ITEM FOR ENVIRONMENTAL COMMISSION AGENDA

NAME & NUMBER OF PROJECT: 6420 Bee Caves Road
SP-2018-0299D

Staff Findings of Fact and Exhibits

ENVIRONMENTAL COMMISSION VARIANCE APPLICATION FORM

IMPERVIOUS COVER	RURAL WATERSHED UPLAND ZONE	SUBURBAN WATERSHED UPLAND ZONE
ALLOWED	0.23 ACRES (20%)	0.63 ACRES (40%)
PROPOSED	0.00 ACRES (0%)	0.78 ACRES (49.7%)

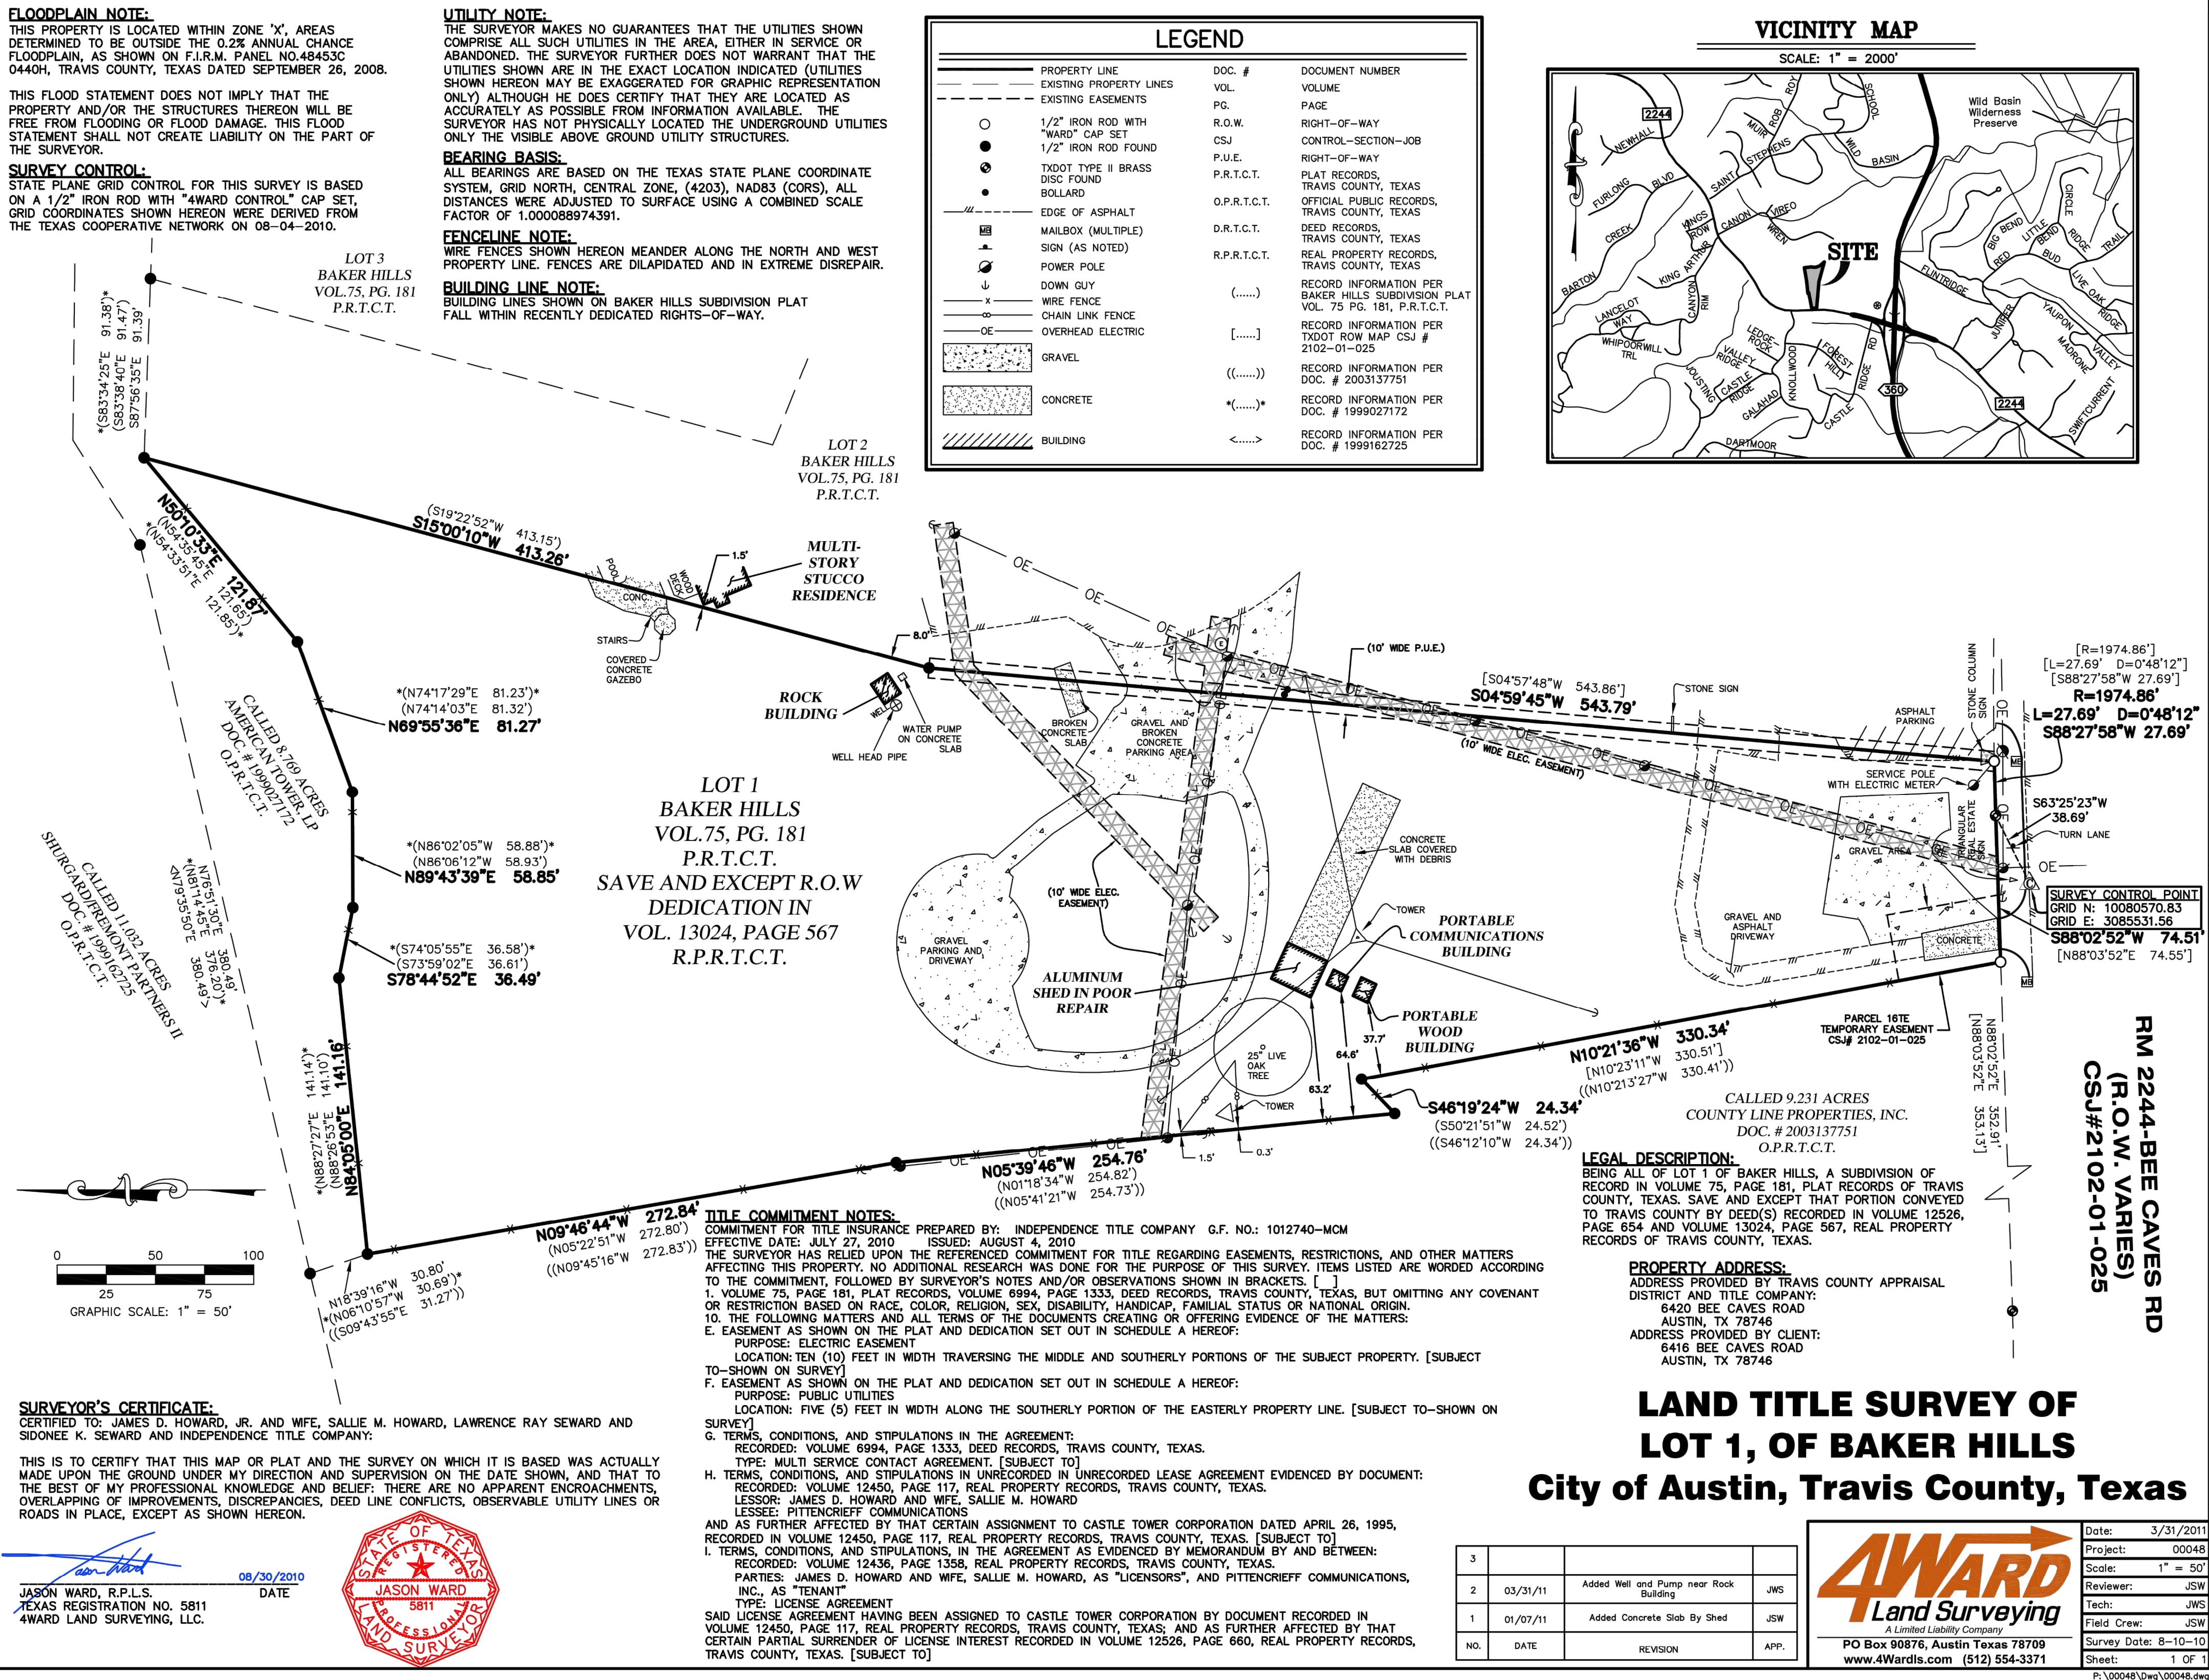
Yes. The variance is required so that the proposed total impervious cover can be contained within the Water Supply Suburban portion of the site, which is the less restrictive watershed classification.

Yes. The proposed impervious cover is less than would be allowed if the two watershed impervious cover limits were to be combined as a whole.

Yes. The variance will allow for all development to be contained within a less sensitive watershed. Additionally, a Restrictive Covenant will be placed on the Water Supply Rural portion of the tract for it to remain undisturbed and undeveloped in perpetuity.

Staff Determination: Staff determines that the findings of fact have been met. Staff recommends the following condition: place a Restrictive Covenant on the Water Supply Rural portion of the tract that restricts any future development from occurring.
